H.1.a.j 953 Balmoral Road – Rezoning Application No. 00598 and Development Permit with Variance Application No. 000506 (North Park)

Committee of the Whole Report For the Meeting of September 6, 2018

Rezoning Application No. 00598 and Development Permit with Variance

Application No. 000506 for 953 Balmoral Road

SITE PLAN & ROOF PLAN | APARTMENTS @ 953 BALMORAL | SCHEMATIC DESIGN FOR DEVELOPMENT PERMIT & REZONING APPLICATION | JANUARY 16 2018 | SCALE 1:100

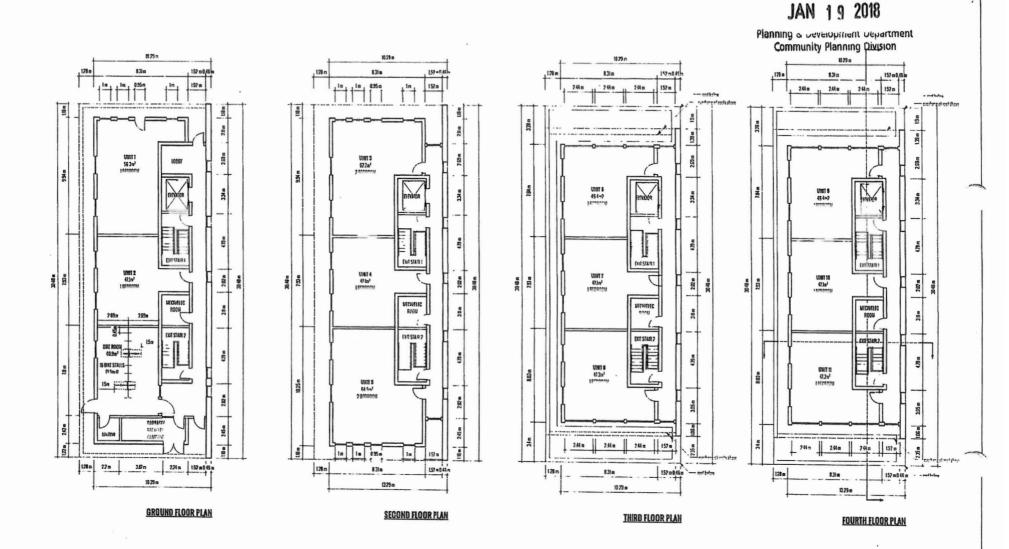
A Statutory Right-of-Way (SRW) of 1.22m is required on Balmoral Road in order to achieve the standard width of a secondary collector street of 20.0m in the Highway Access Bylaw. The applicant will provide the SRW and has shown it on the site plan.

Diagram -Permeable paver driveway crossing over Critical Root Zone

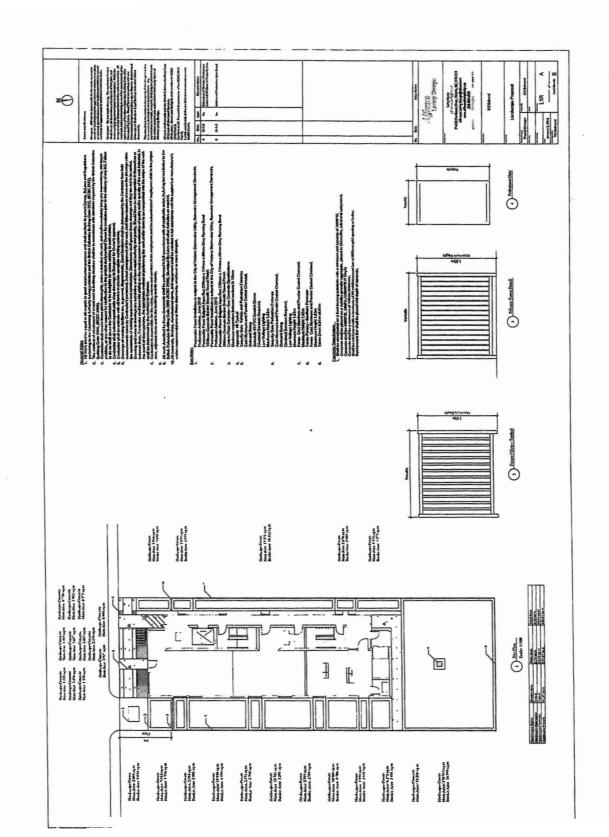
- Landscaping: According to the landscape plans provided, pavers are to be installed in the area between the proposed building and parking stalls. If the area within the tree's critical root zone cannot be retained as is or designed with 'softscape' elements, we recommend the pavers be permeable to maximize water percolation to the tree's roots. The grade of these pavers must also be installed in a manner that limits excavation below the existing site grade.
- Pruning: The tree's canopy extends 4-5m over the property line and approximately 7m north
 towards the proposed building. The tree's crown extends nearly to ground level. Pruning will
 be required for clearance above the parking lot and may be required for clearance for the
 building construction, but such pruning should not significantly impact the tree's health or
 stability.

- 4. Revise the landscape plan to indicate floating pavement where the proposed parking spaces overlap with the tree's critical root zone in accordance with the arborist report prepared by Talbot Mackenzie & Associates.
